MIL-F-12869H (PA)
AMENDMENT 2
3 April 1975
SUPERSEDING
AMENDMENT 1
18 September 1974

MILITARY SPECIFICATION

FUZE, POINT DETONATING, M524A6

PARTS FOR

FIGURE III

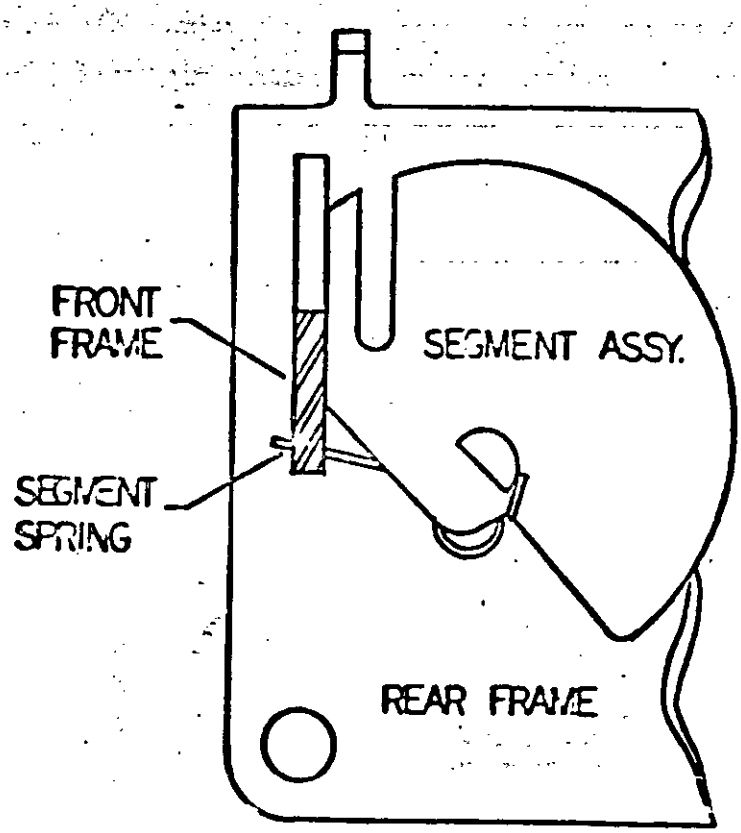
8. Para. 4.3.2.4, Minor category: add "204 Trigger spring or segment spring assembled under rear or front frame (see Figure II and III)...Visual"

42. Add Figure III to "Notes" section.

FIGURE II

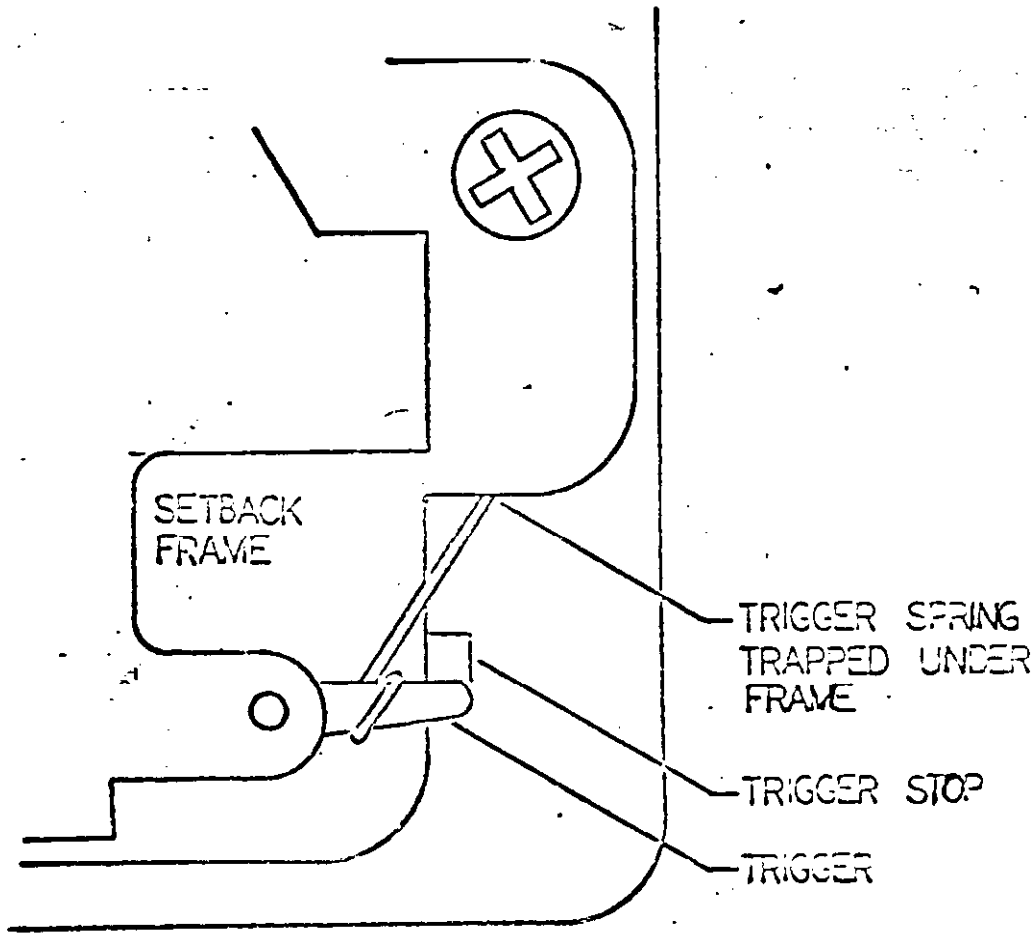
41. Add Figure II to "Notes" section.
